Coffs Harbour Bypass

Submissions Report

Volume 1. Executive summary, Chapters 1-3

Coffs Harbour Bypass
Native vegetation
Figure 3.4-1-01

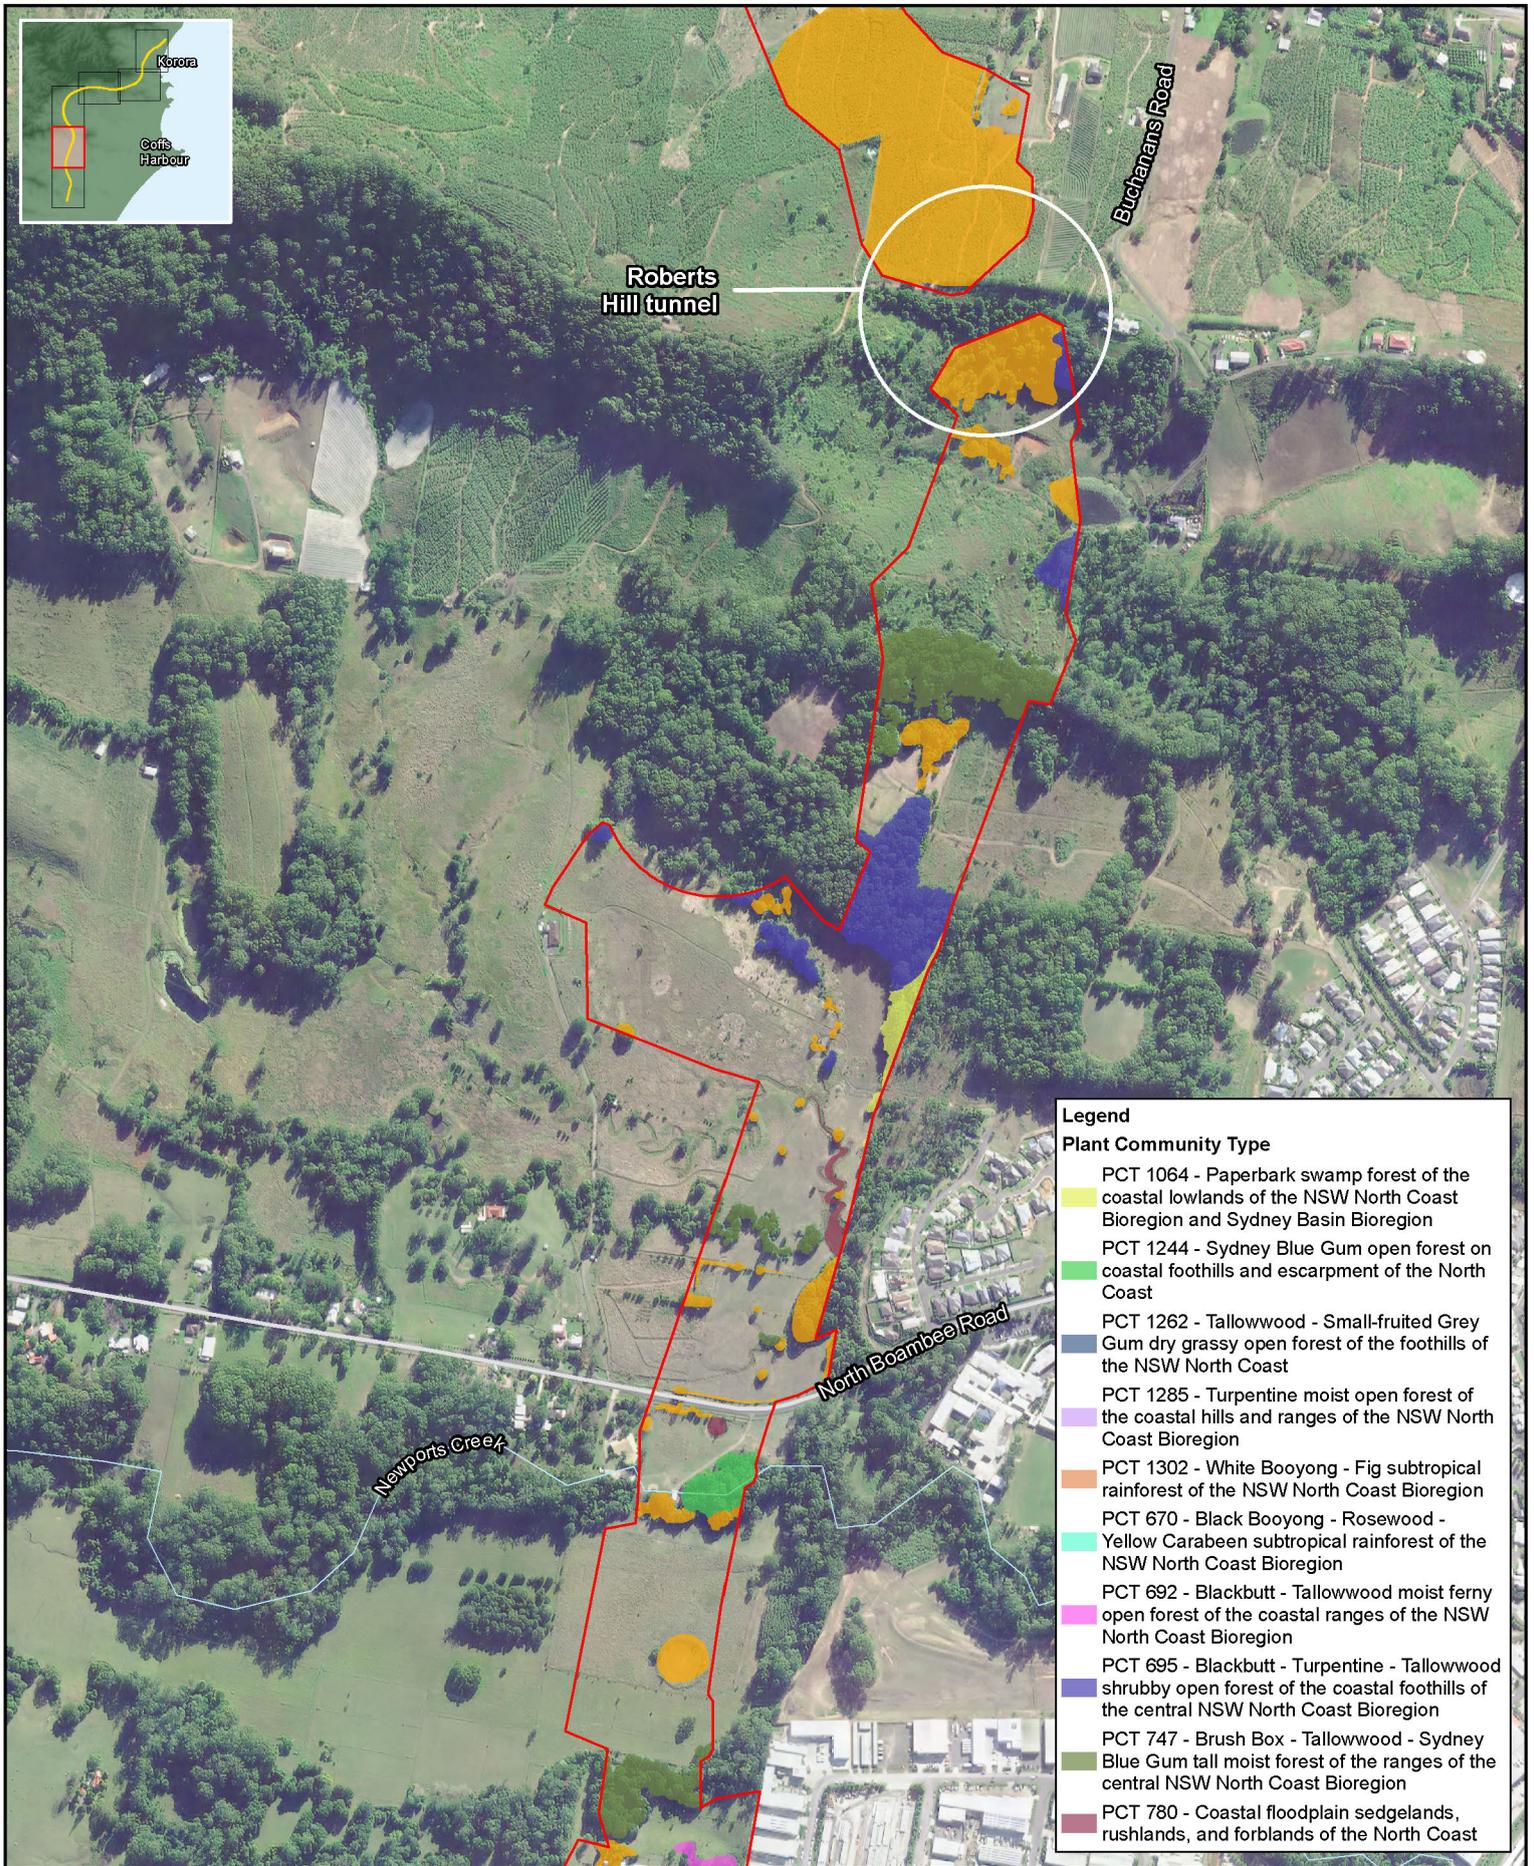
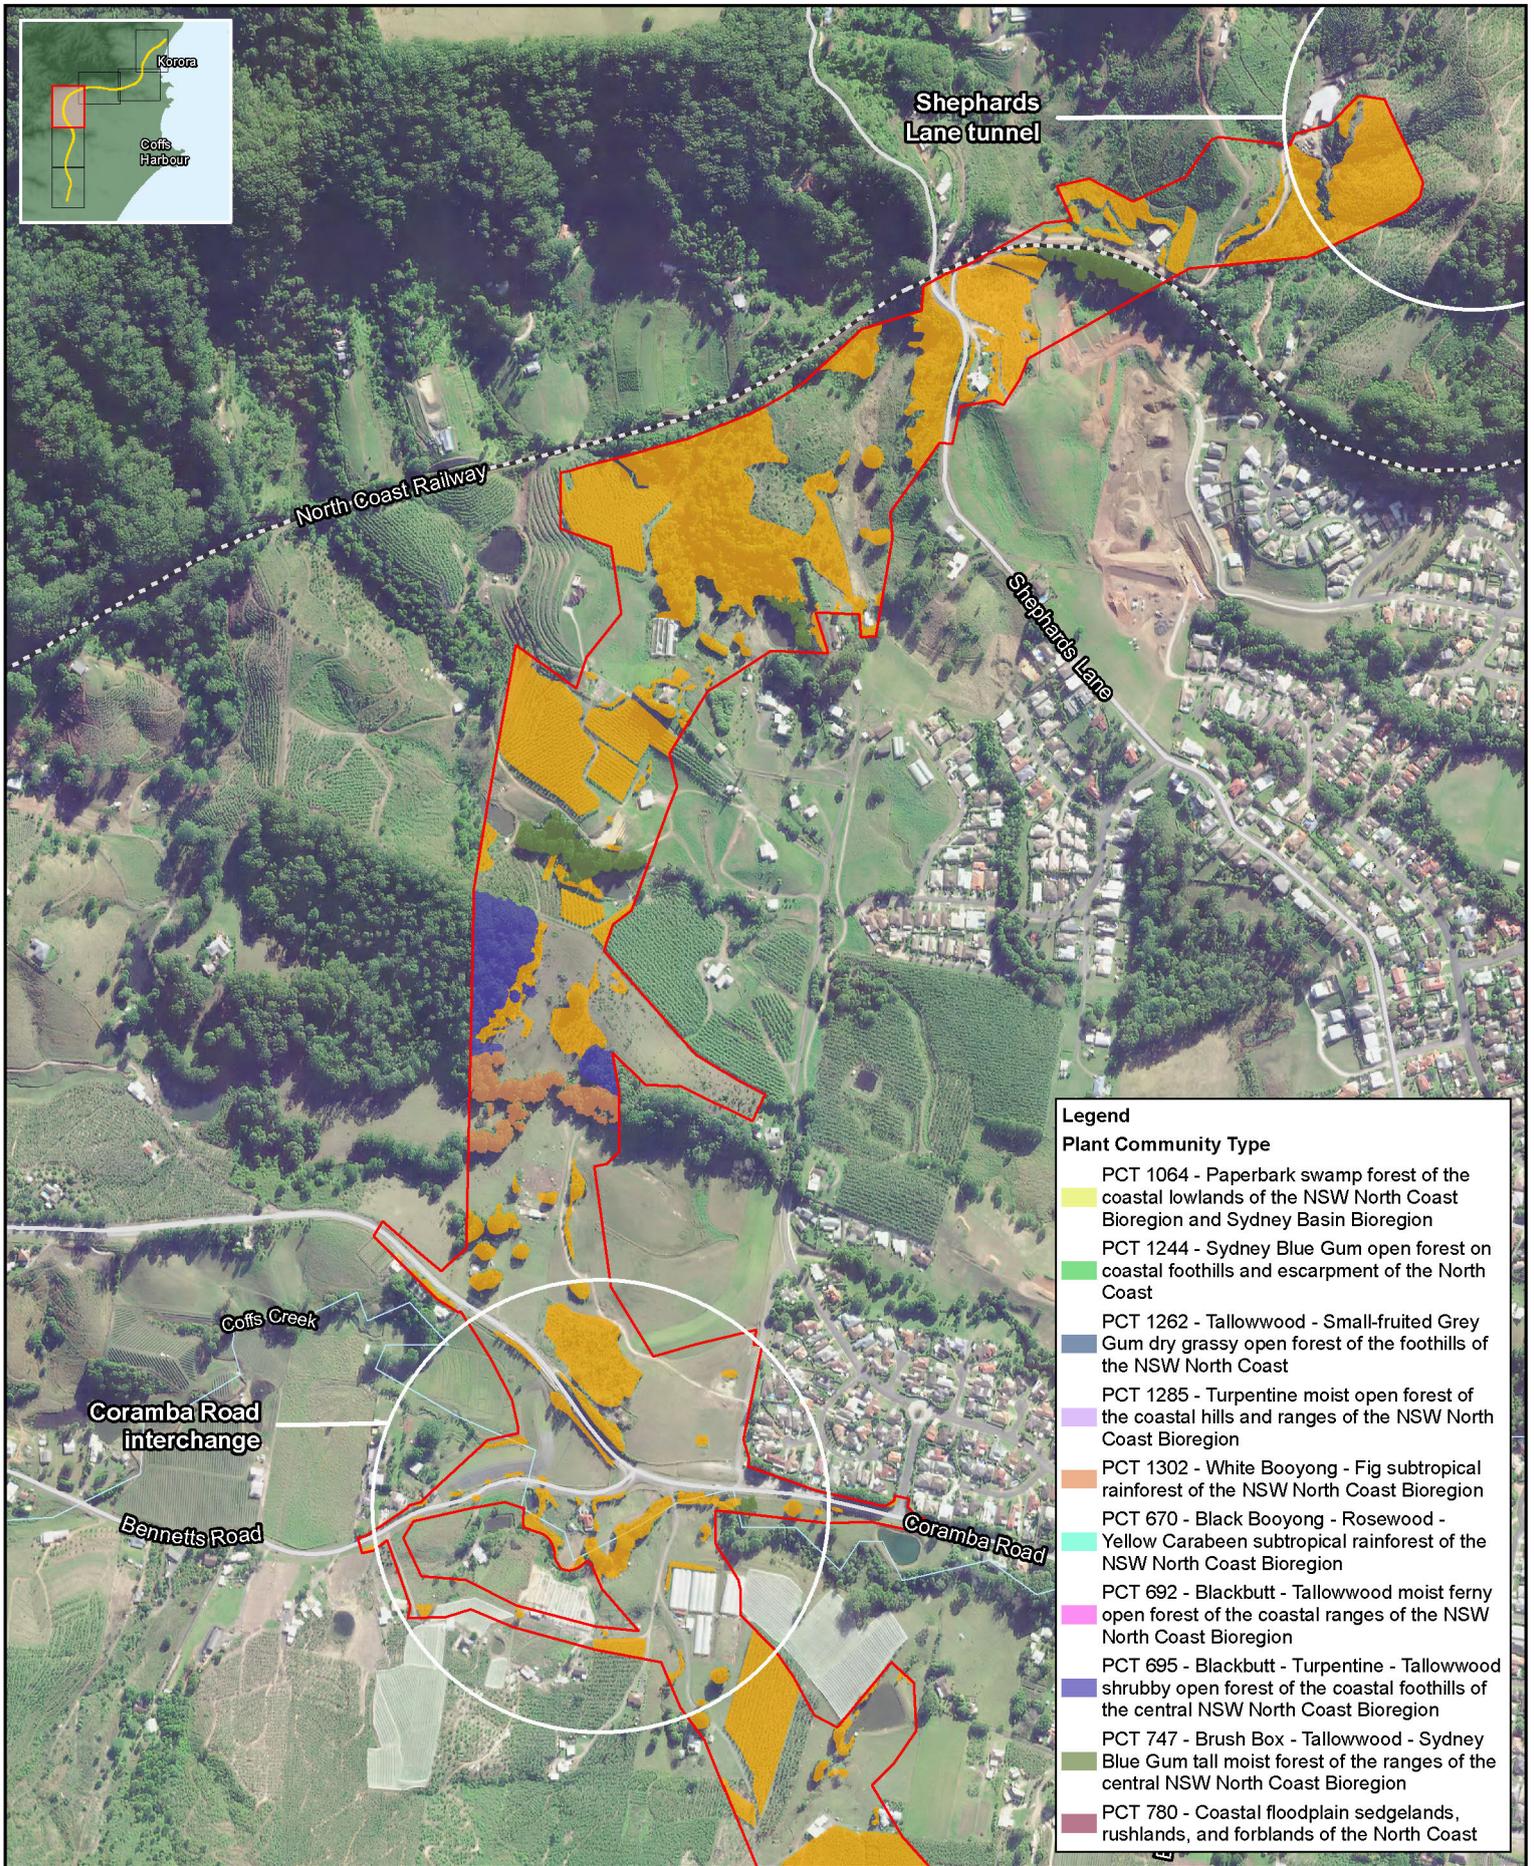
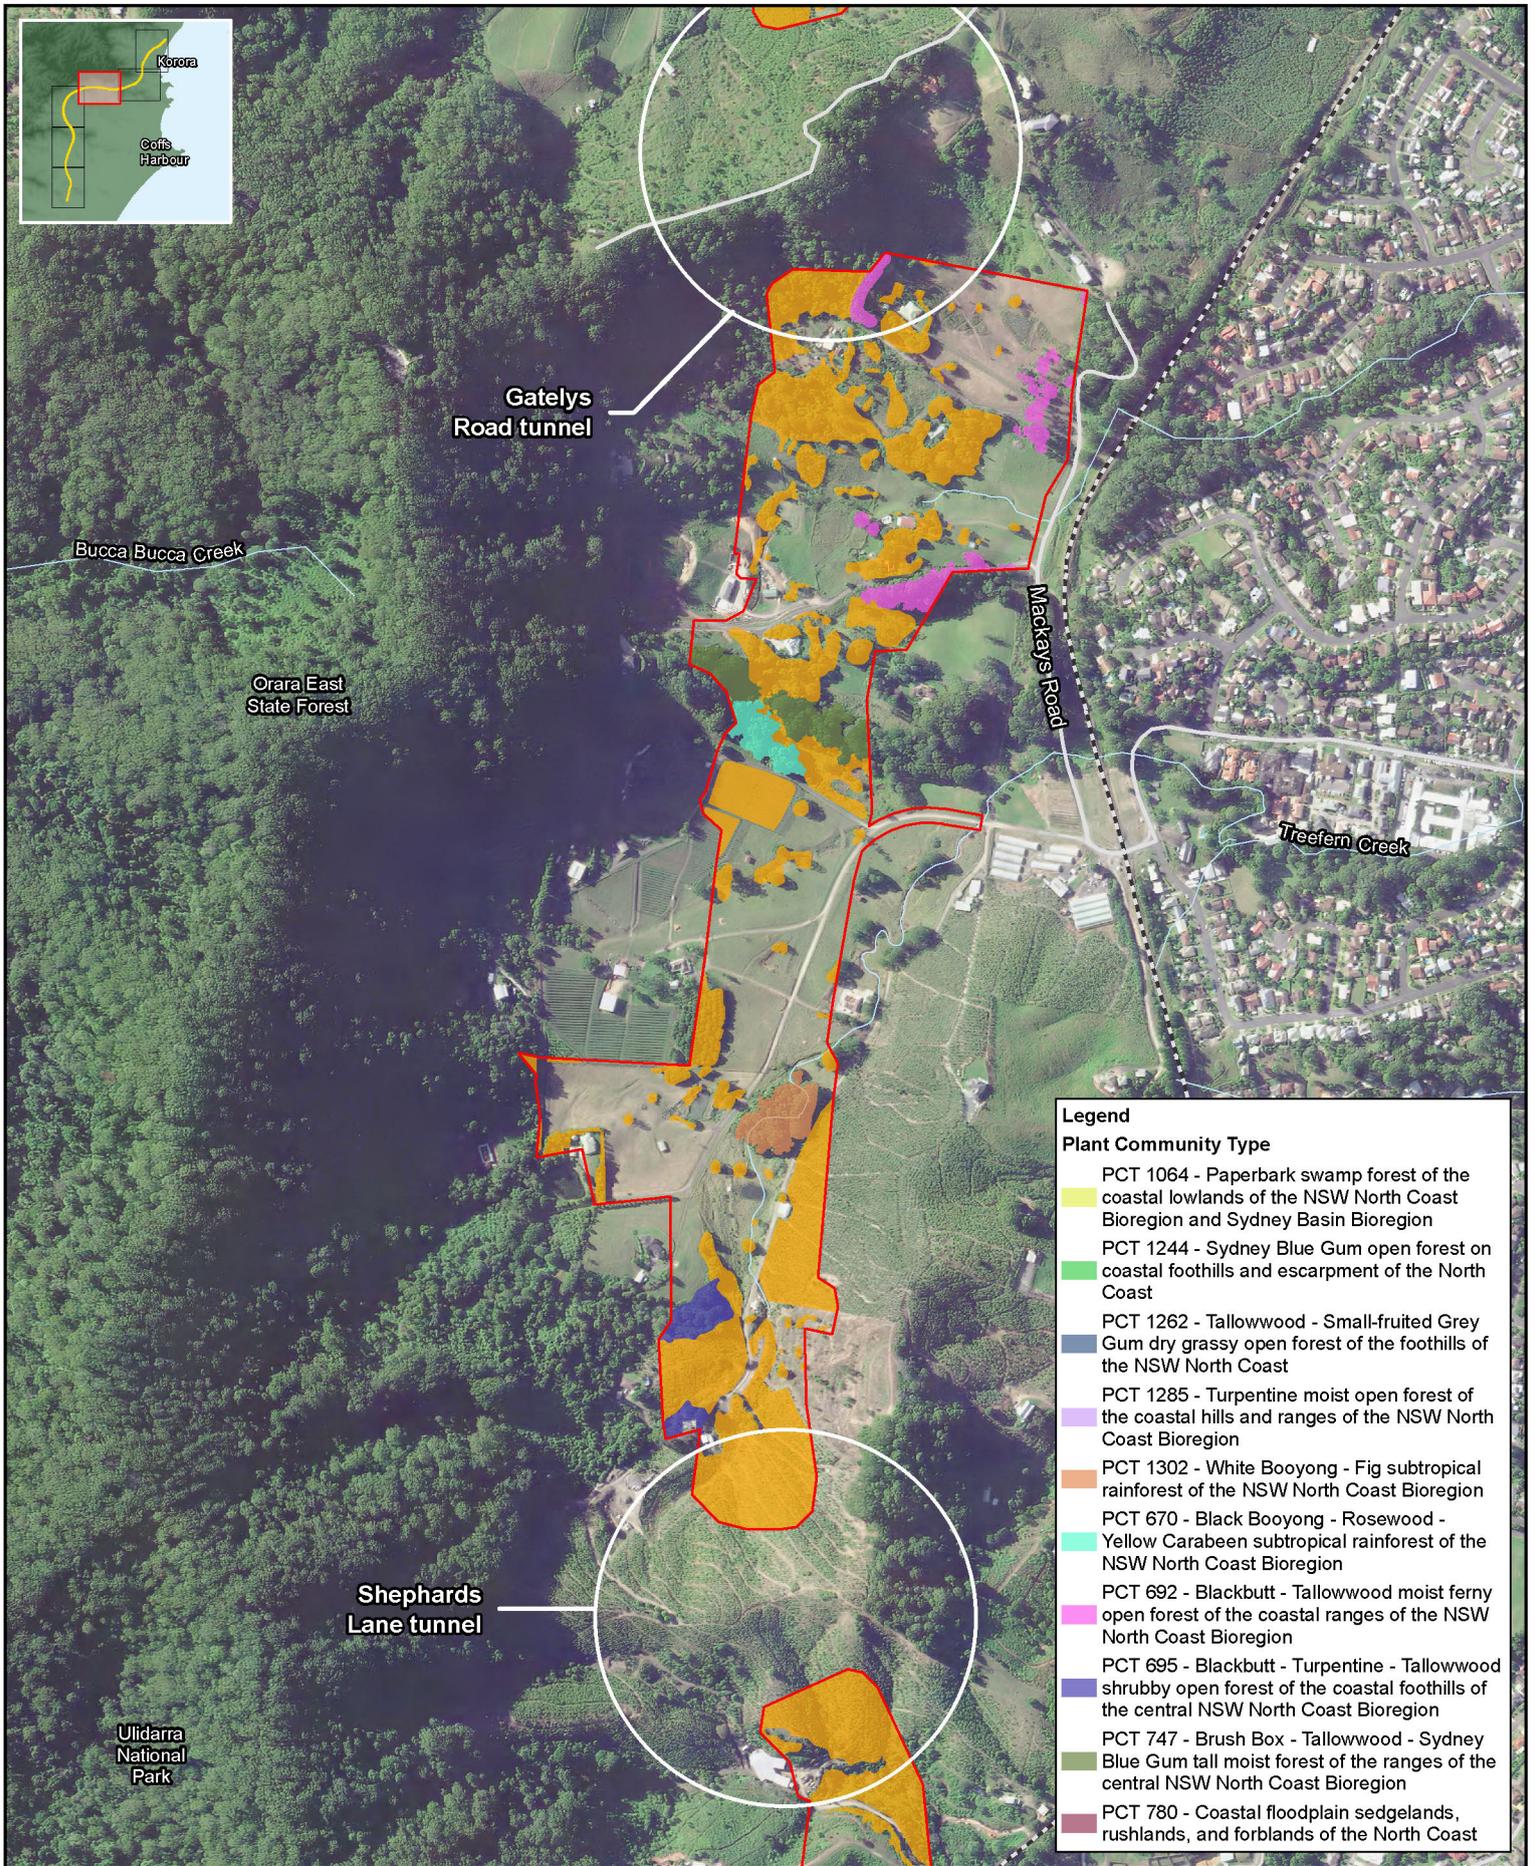
- Any areas of freshwater wetland within the development site must be mapped and assessed, and the results presented in the Biodiversity Assessment Report
- Any freshwater wetlands identified must be assessed to determine whether they align with the freshwater wetland on coastal floodplains endangered ecological community (EEC) determination.

- The two patches of wetland vegetation, north and south of North Boambee Road, have been added because of a change in the condition of the vegetation since the original PCT mapping was carried out in 2016. These areas are described in detail in Section 3.1.2 of Appendix C, Updated biodiversity assessment report of the Amendment Report and shown on Figures 4.1 to 4.7. Locations of updated PCT 780 are provided in **Figure 3.4-1-01** to **Figure 3.4-1-06**.

These areas are described in detail in Section 3.1.2 of Appendix C, Updated biodiversity assessment report of the Amendment Report and shown on **Figure 3.4-1-01** to **Figure 3.4-1-06**.

Figure 3.4-1-01 to Figure 3.4-1-06 shows the extent of vegetation within the study area that has been assessed as urban native/exotic dominant communities. These figures are also included in Appendix C, Updated biodiversity assessment report of the Amendment Report (Figures 4.1 to 4.7). These communities do not have the floristic composition or structure to be assigned a PCT type.
